Access Compliance Report

Public Rights-of-Way

Intersection ID: 31537	Main Street: CARLEEN_WAY_DR	Cross Street: GRIER_SPRINGS_LN	Location: W
ADA ID: EFA33A6615E3	Ramp Type: BlendTrans1	Initial Pass/Fail: Fail	Overall Compliance: No
Severity Score: 17.5			
Codes/Mitigation Info/Possible Solution		Field Measurements/Component Compliance

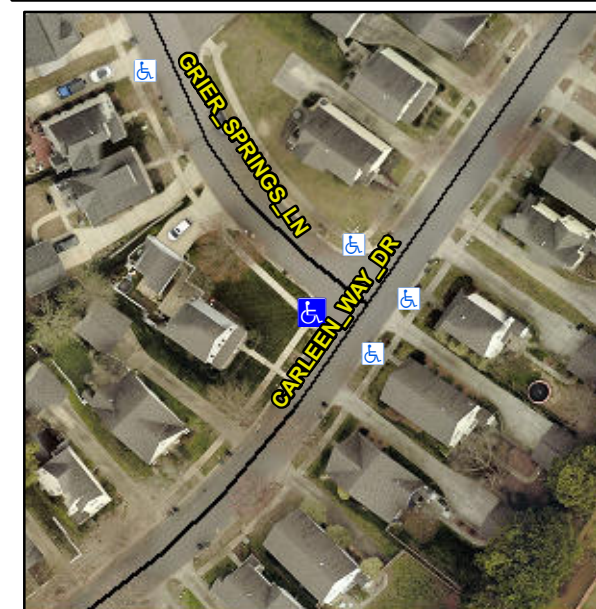
R304.5.1

Compliance	Description	Data	Compliance	Description	Data
N/A	Ramp Length (in)	53.0	Yes	BlendTrans Slope (%)	4.1
No	Ramp Width (in)	34.0	Yes	BlendTrans XSlope (%)	1.6
N/A	Flare Type LT	N/A	N/A	Flare Type RT	N/A
N/A	Flare Slope LT (%)	N/A	N/A	Flare Slope RT (%)	N/A
N/A	Flare Traversable LT?	N/A	N/A	Flare Traversable RT?	N/A
N/A	Landing Length (in)	N/A	N/A	DWS Provided?	N/A
N/A	Landing Width (in)	N/A	N/A	DWS Contrast?	N/A
N/A	Landing Slope (%)	N/A	N/A	DWS Length (in)	N/A
N/A	Landing X Slope (%)	N/A	N/A	DWS Full Width?	N/A
N/A	Landing Curb? (Y/N)	N/A	N/A	DWS Offset (in)	N/A
N/A	Shared Landing?	N/A			
N/A	Gutter Ponding?	N/A	N/A	Gutter Slope (%)	N/A
N/A	Gutter Lip Ht (in)	N/A	N/A	Gutter X Slope (%)	N/A
N/A	Painted X Walk1?	No	N/A	Painted X Walk2?	No
	X Walk 1 Direction	To SE		X Walk 2 Direction	To NE
	X Walk 1 Width (in)	N/A		X Walk 2 Width (in)	N/A
	X Walk 1 Slope (%)	3.5		X Walk 2 Slope (%)	2.3
	X Walk 1 X Slope (%)	1.2		X Walk 2 X Slope (%)	3.7

Remove & Replace Curb Ramp With Two New Directional Ramps or Equivalent.
